APPLICATION FOR SITE PLAN REVIEW

TO THE CITY OF PORTSMOUTH
FOR 1151 SAGAMORE AVENUE

Re: Request for Site Plan Review at 1151 Sagamore Avenue, Tax Map 224, Lot 19

TAC Comments

BRE DEVELOPMENT HYDROLOGY PLAN

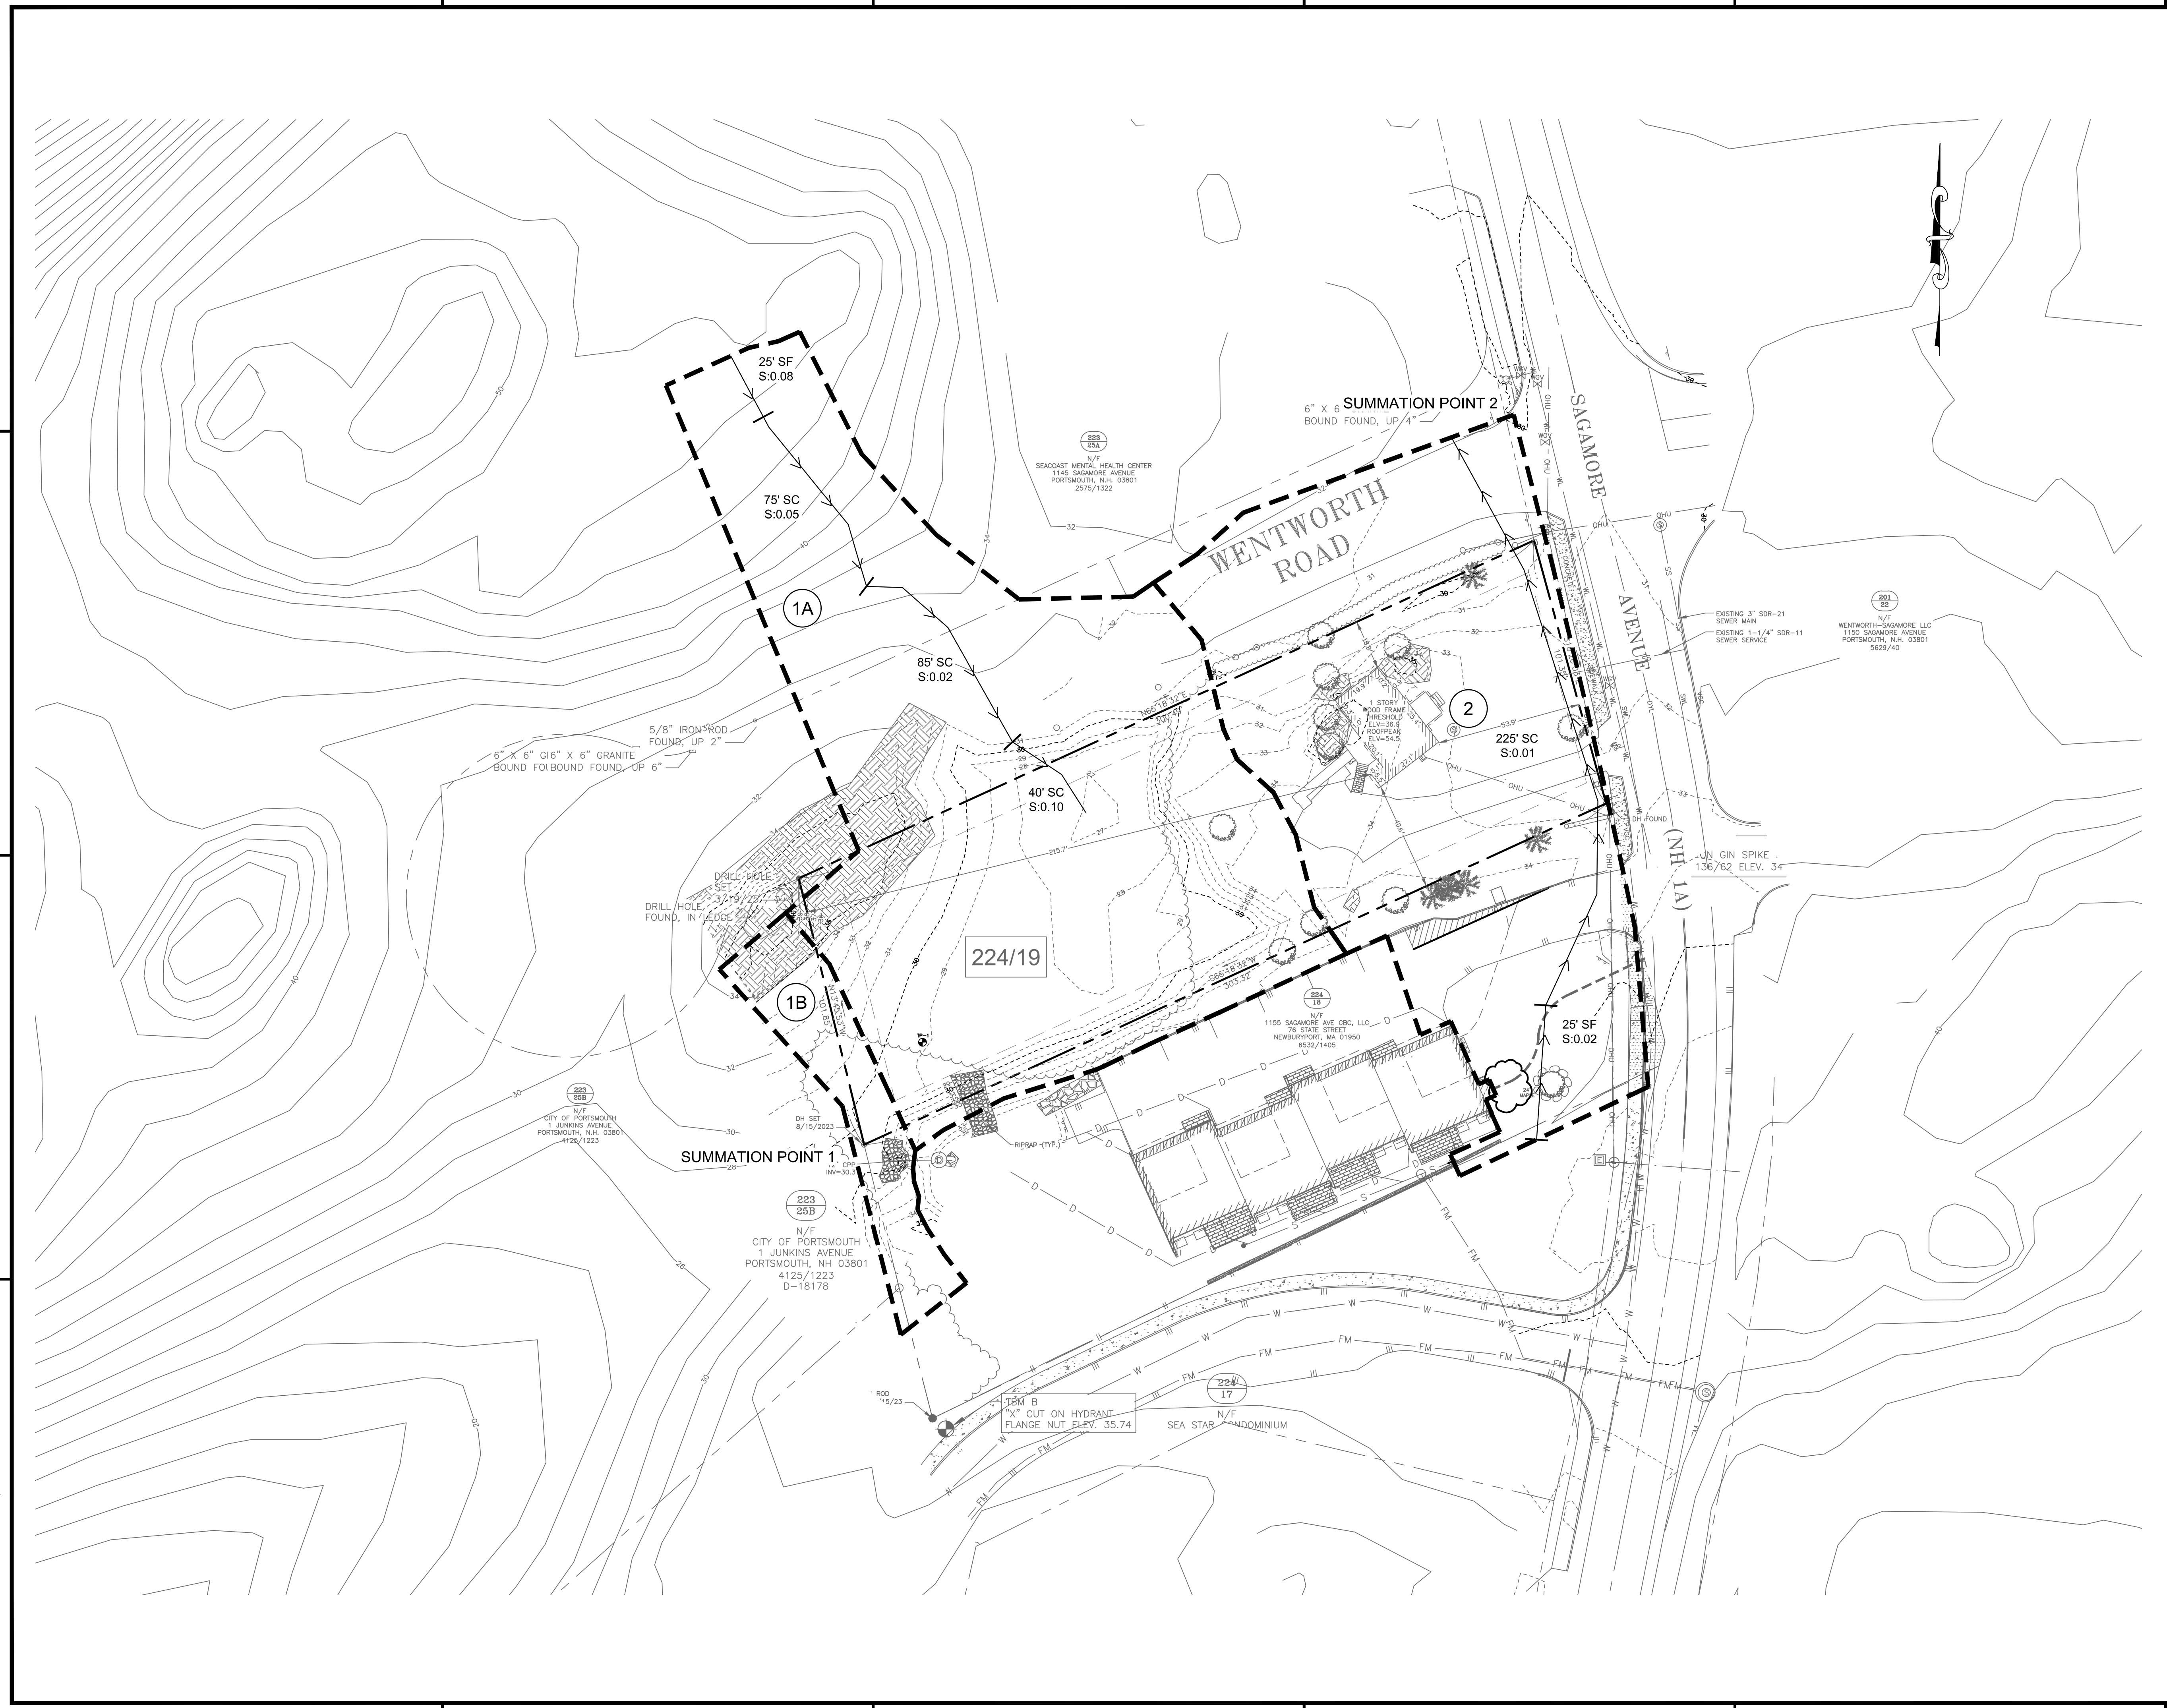
11. The topography provided in the existing features plan does not match up with the drainage pattern provided in the drain study. It appears there is a large depression in the center of the lot that would naturally detain stormwater. This is not represented in the study. Also, as offsite flow onto the site needs to be accounted for in design, it is not relevant to the pre and post condition Summary and the offsite areas should have been shown a routing separately. In short, we believe that developing this site to the degree shown will dramatically influence the downstream drainage and that needs to be addressed.

HW Response: The previously submitted hydrology plans were prepared with the understanding that the “large depression” in the center of the lot was man-made and created prior to the field-survey of the lot. The intent of the pre-development hydrology model was to reflect the true “existing condition” of the site, i.e. its condition prior to the disturbance of the lot which has been ongoing since early 2025. Upon further review it was determined that this depression was existing prior to the survey (albeit it has been excavated further since the survey.)

The pre-development hydrology model has been revised to include this depression. Additionally, topography data for the offsite area to the north which drains to this depression was provided by the City's GIS department and was used to delineate the watershed area of this depression.

As a result of the inclusion of this detention area within the pre-development hydrology model, it was determined that additional detention measures would be needed for the proposed site in order to reduce post-development peak stormwater discharge rates to pre-development levels. This was accomplished via the inclusion of two stormwater infiltration systems; one along the northern property line, and one beneath the proposed driveway. These systems have been designed to accommodate the seasonal high water table elevation as determined by a test pit performed in 2025. A revised Drainage Report has been provided with this application.

PROJECT	1151 SAGAMORE AVENUE CBC, LLC 1151 SAGAMORE AVE., PORTSMOUTH NH		DWG No.	BY
TITLE	TURNING EXHIBIT RIGHT TURN ENTERING COMPLEX	TR-2	PJM	
		JN 5010314.002	DATE	2025.12.22
		SCALE 1"=20'	REV.	
			REV. DATE

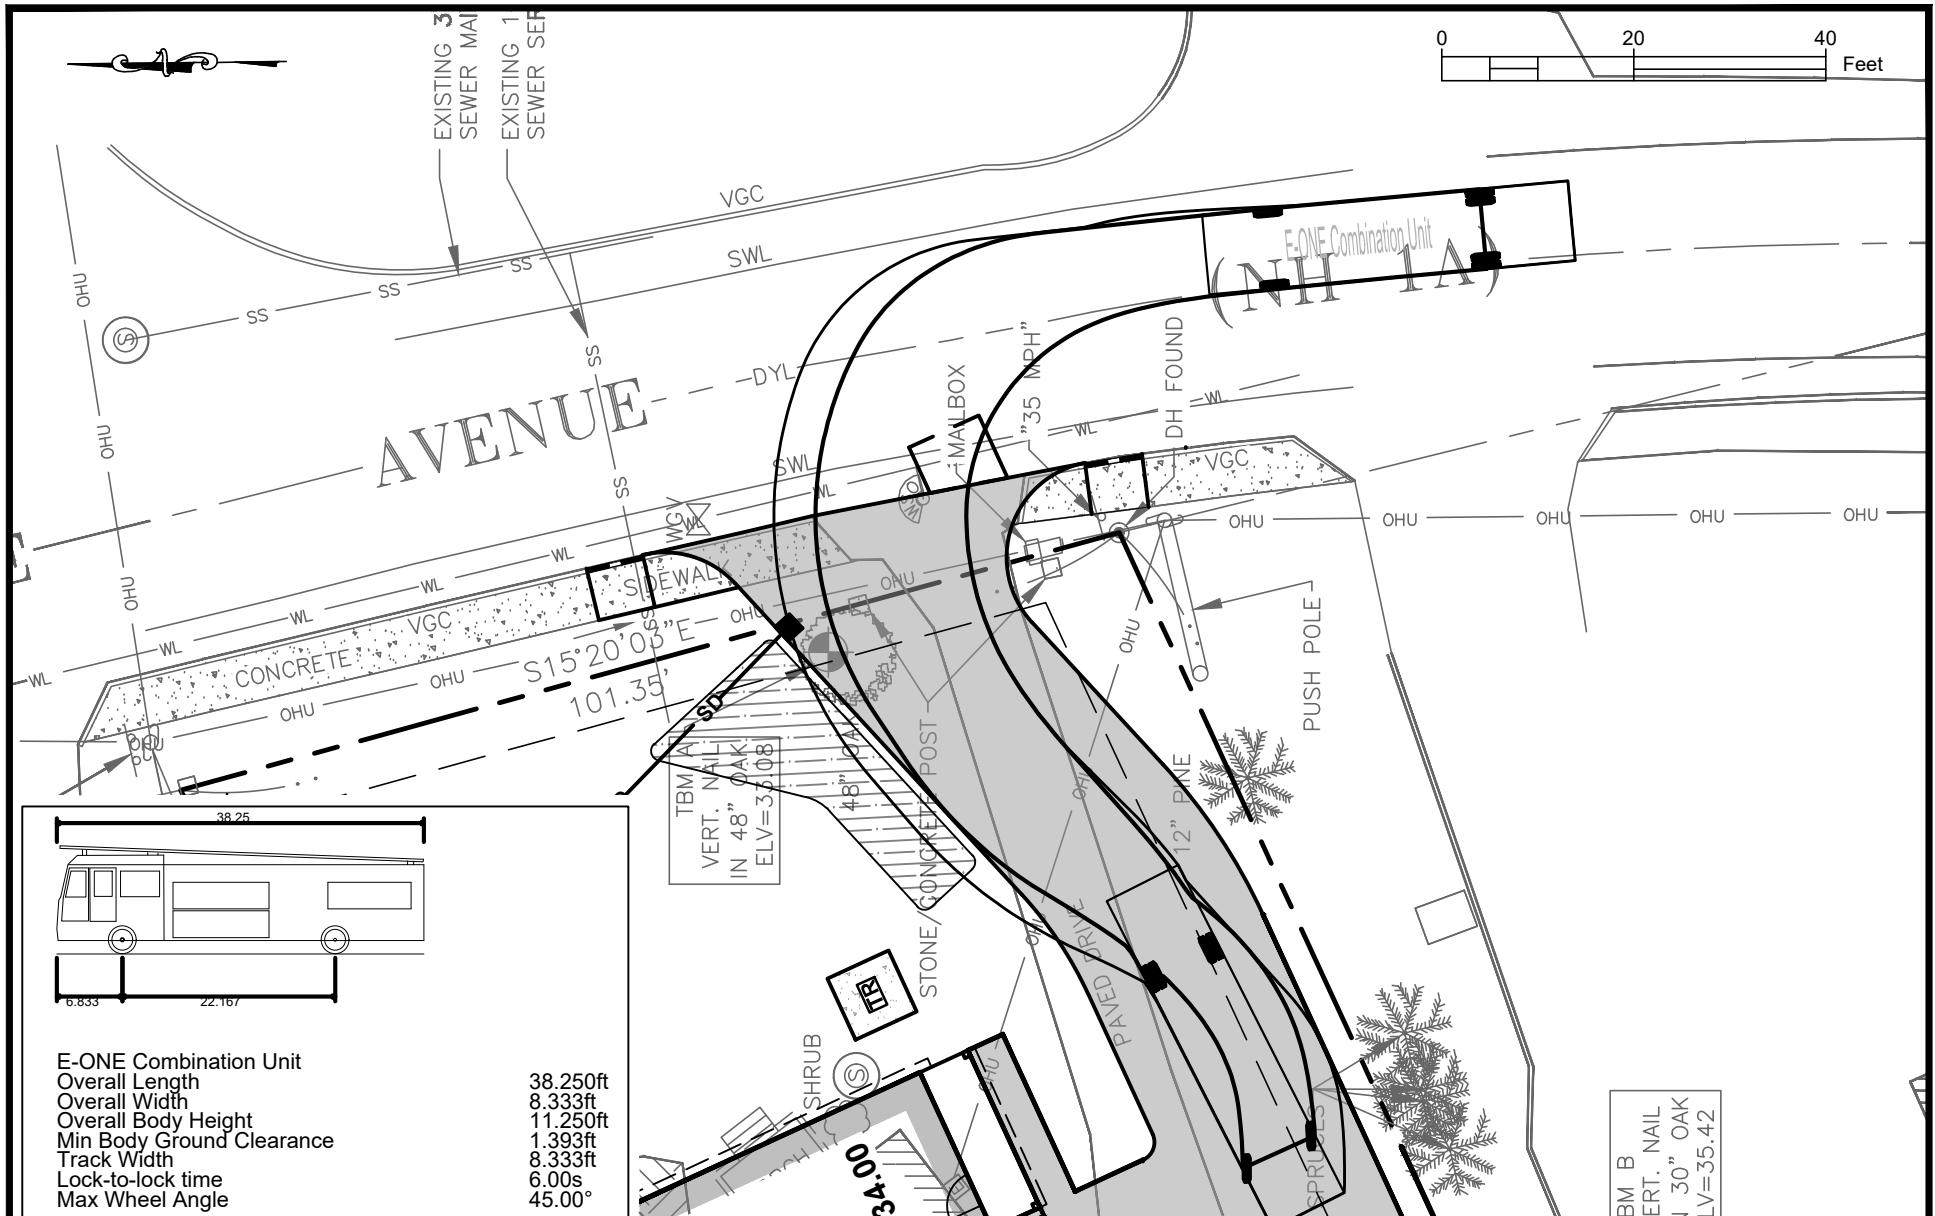
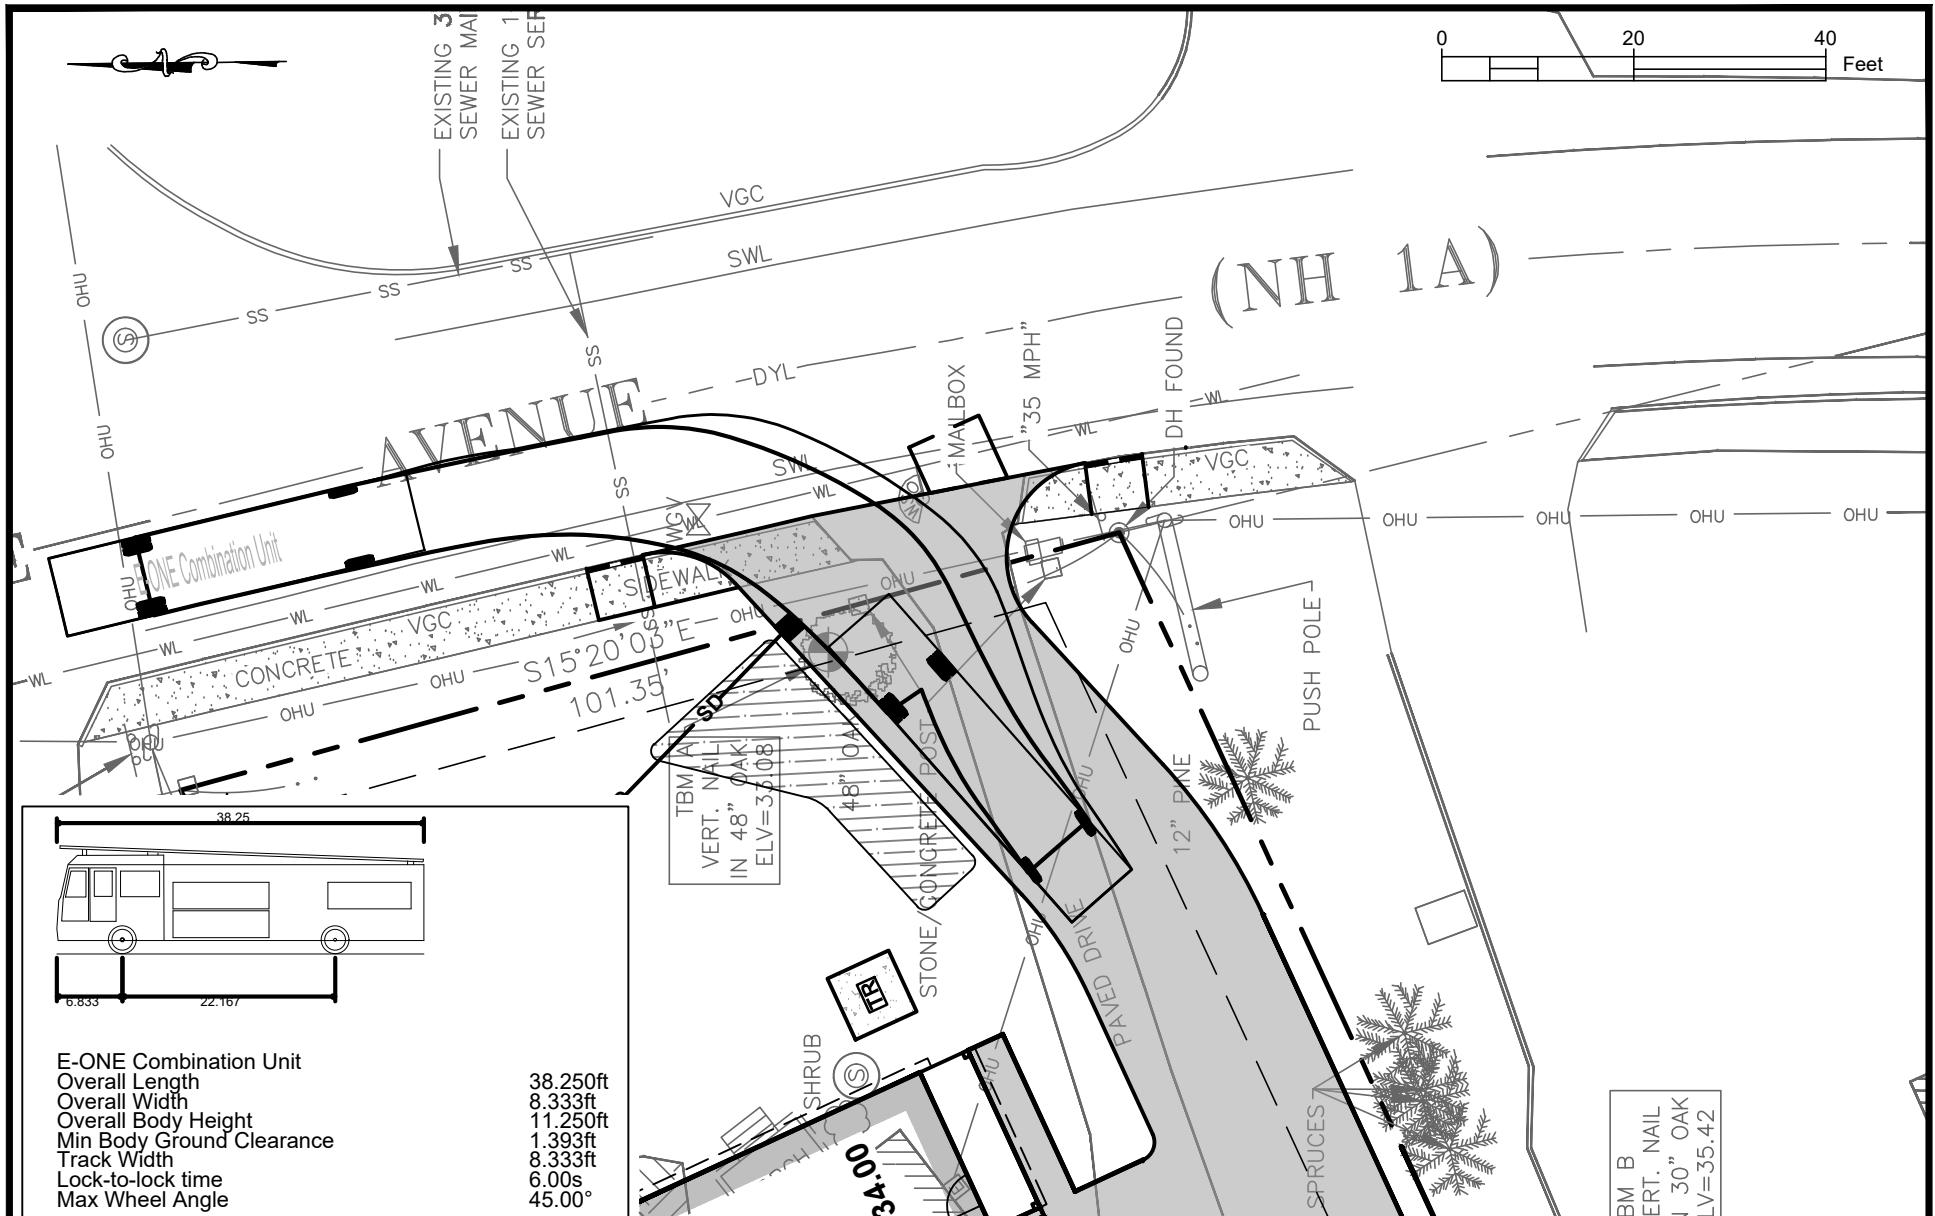
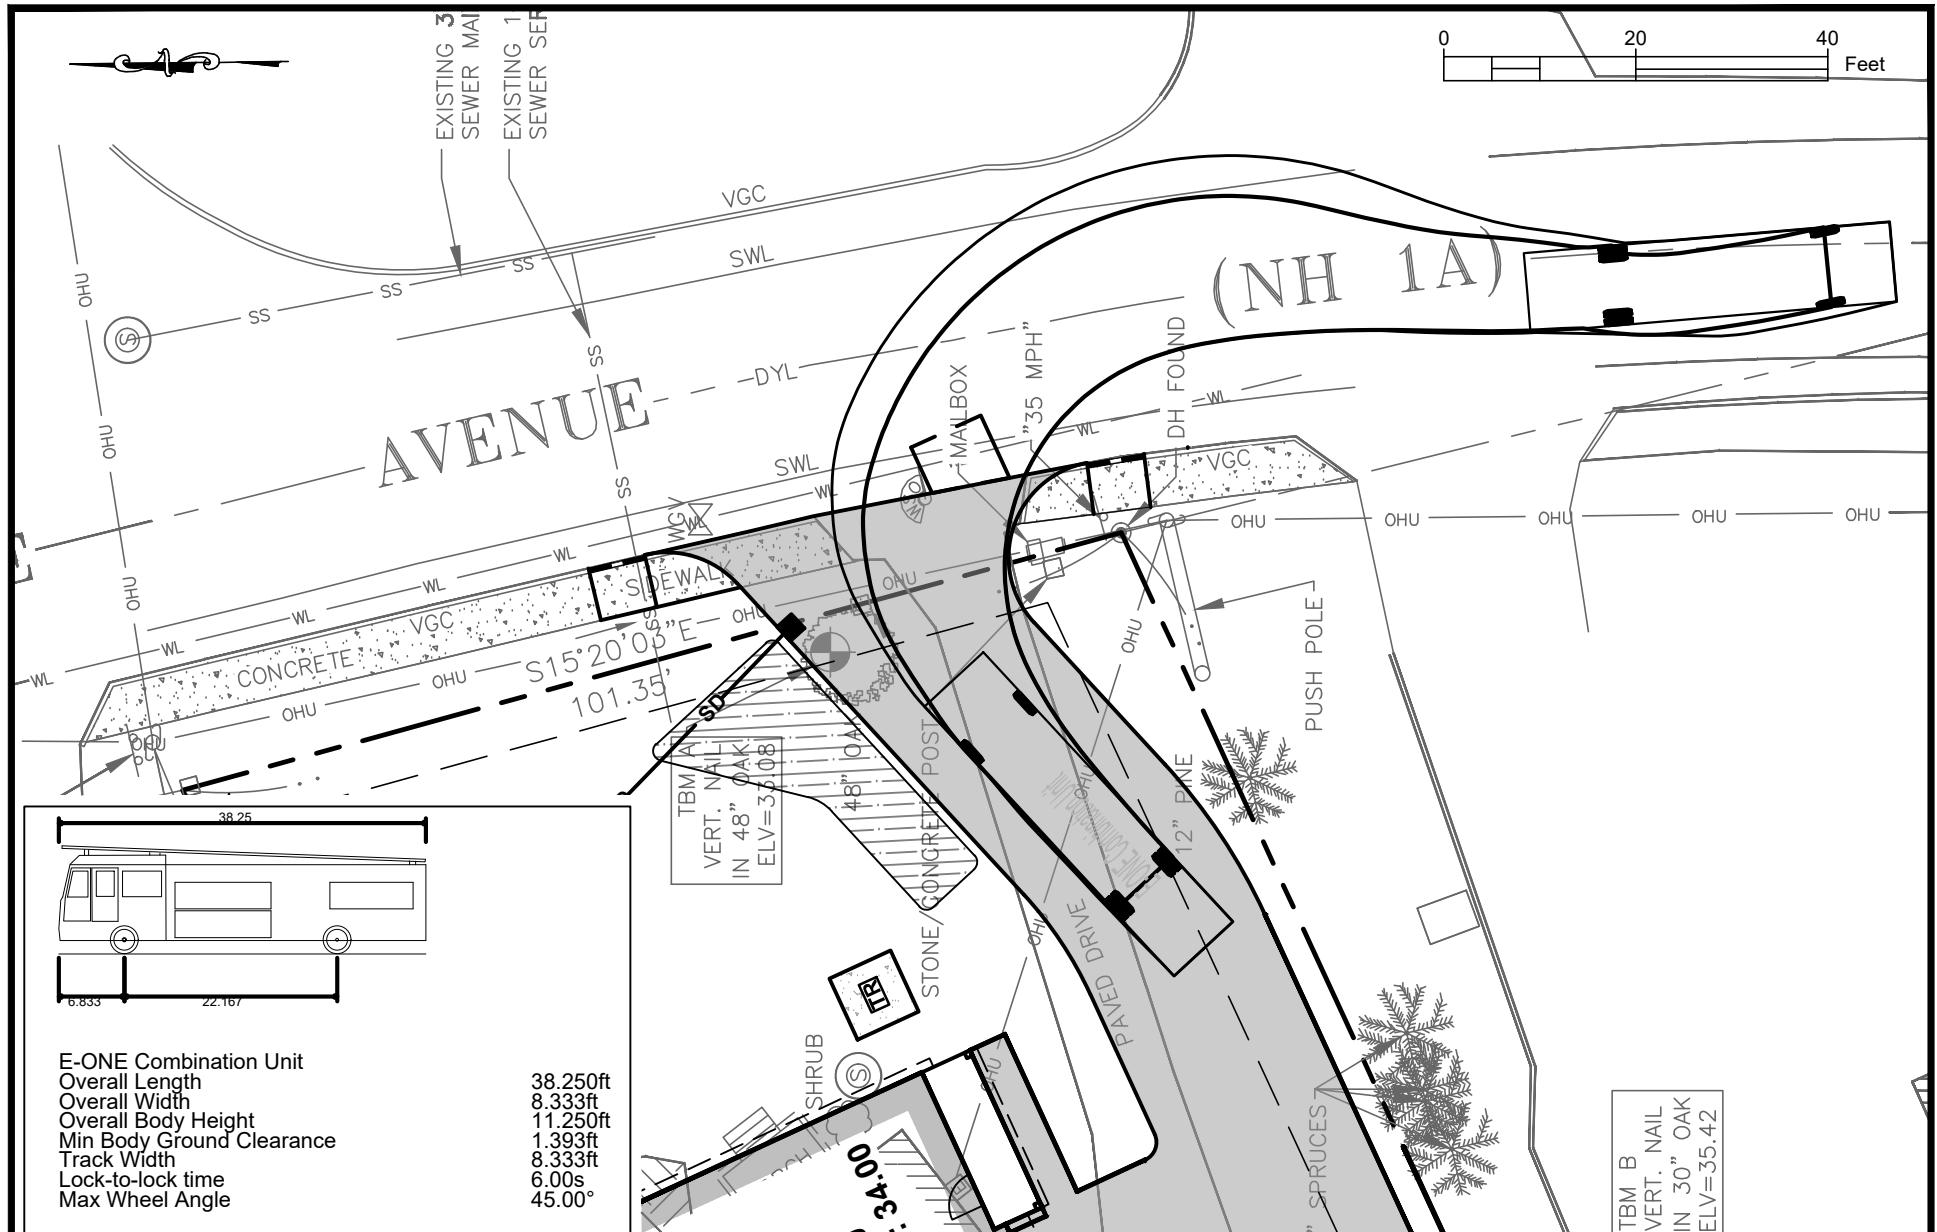
4. South side of the driveway does not need radius. Remove radius and continue straight line of driveway until it intersects with Sagamore Ave.

HW Response: The driveway entrance was originally located further south but was shifted north at the direction of NHDOT. This radius is necessary to accommodate emergency vehicle accessing the site from north-bound Sagamore Ave as shown on the turning movement diagrams included within the drawing set.
